Leaf Grade Casualwear Ltd.

Kewa (Madrasha Road), Sreepur, Gazipur

14th June 2017

Observation

Observation: (Production Shed)

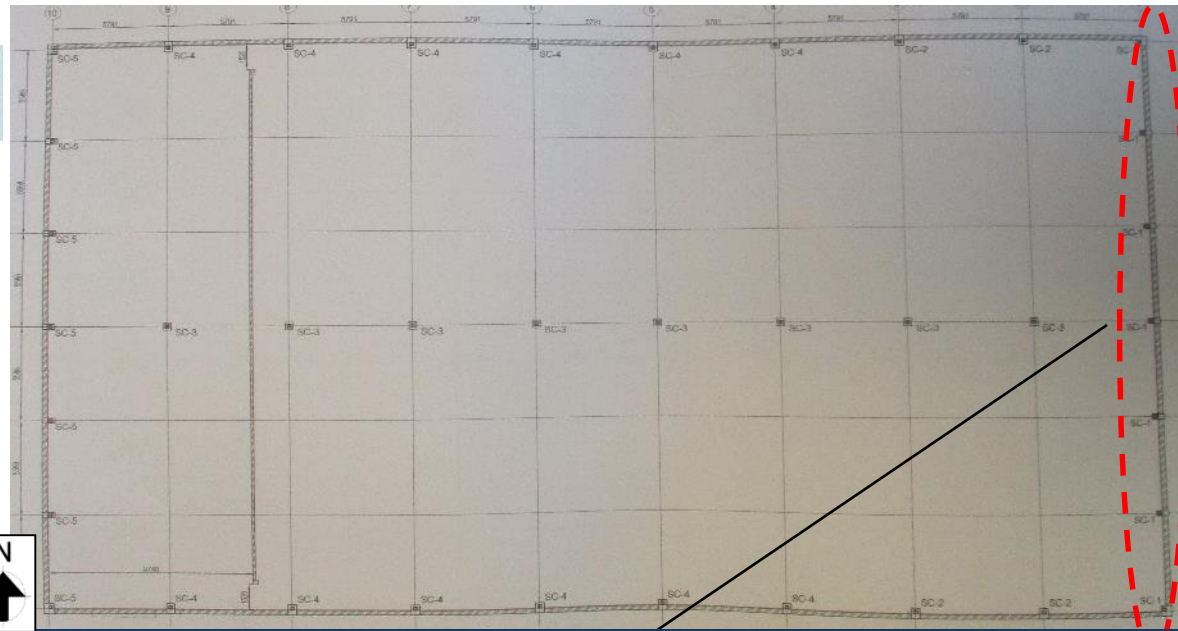
Lack of lateral stability

No roof bracing

Discontinued Vertical bracing.

Only continued vertical bracing

Specific lateral load resisting system (bracing and compression strut) wasn't observed. Factory is required to engage an engineer for assessment the lateral stability of the shed.

Column layout plan in provided drawing

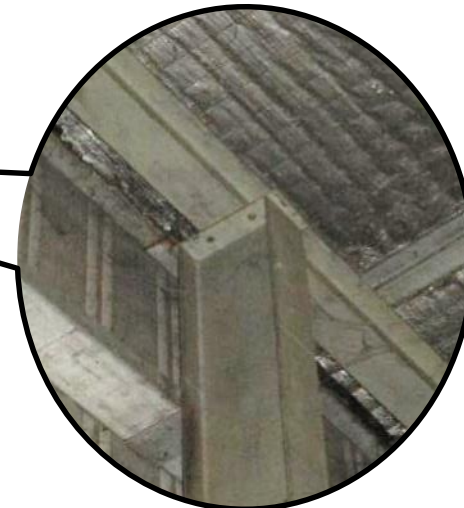
Lack of connection details

On grid 1-1, bolt was missing on several column rafter joint. In addition, no welding was observed on the joint. Factory is required to engage an engineer to check the joint adequacy and take remedial measures.

End wall framing at grid 1-1

No bolt was observed Column and rafter joint

Observation: (Production Shed)

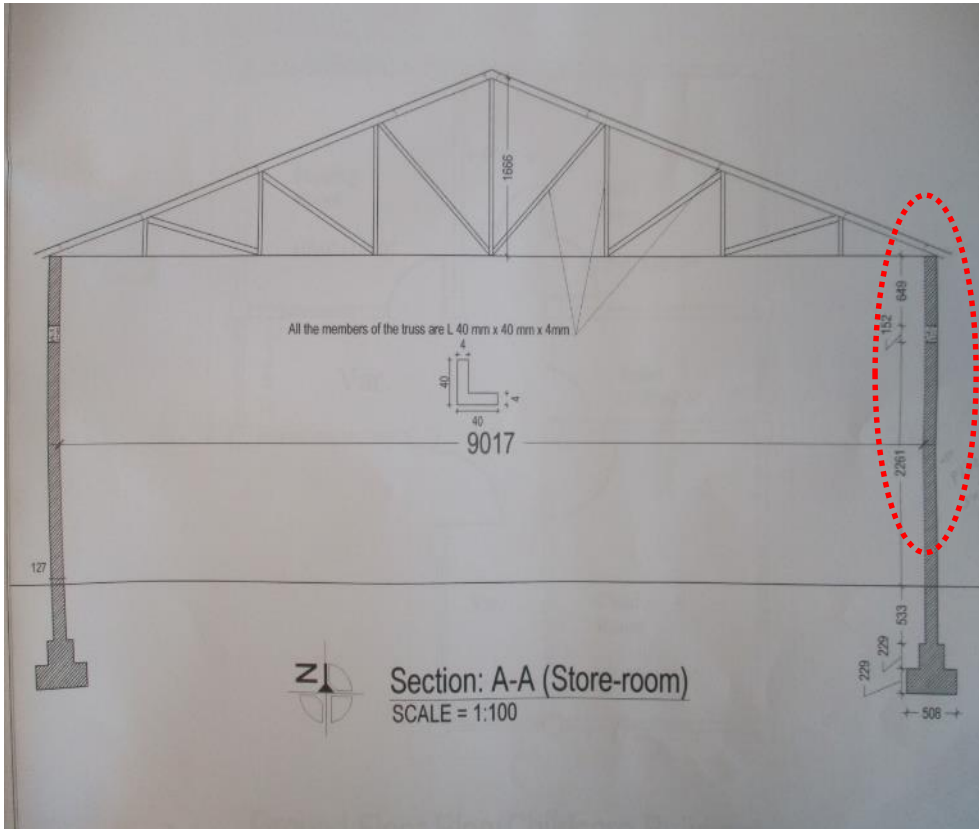
Corrosion observed on structural steel members

Corrosion on column in front of north west toilet area

Corrosion on column in front of north east toilet area

Corrosion on column rafter joint.

Corrosion may cause damage on structural members. Factory is required to repair the corrosion and provide the anti-corrosion paint.

Observation:(Childcare Building)

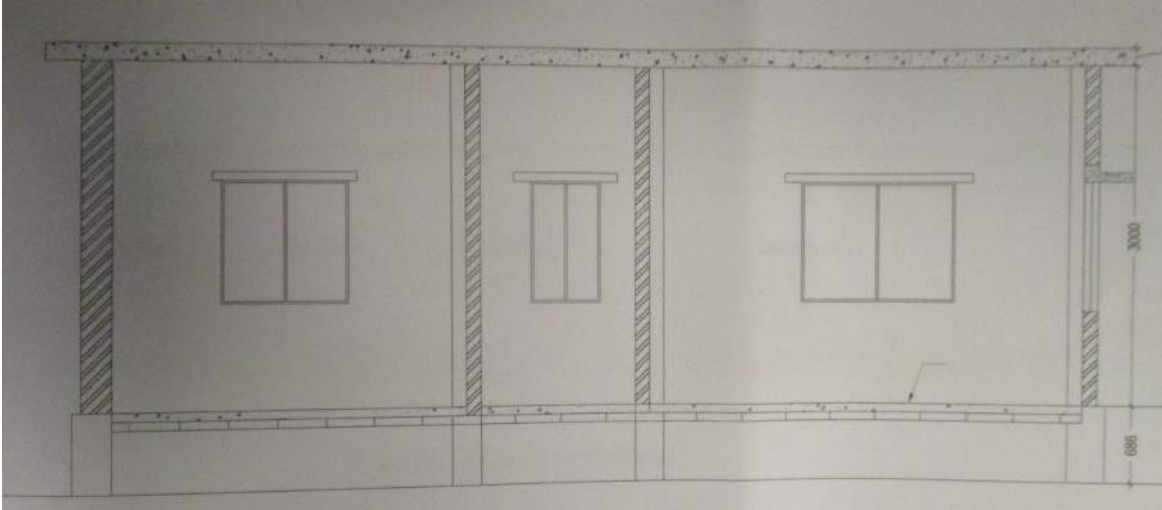
Lack of information in as-build drawing

Extent of Childcare building

Sectional view of the building

No detail about the support condition was present in provided drawing. Factory is required to engage an engineer for produce a detail as-build drawing
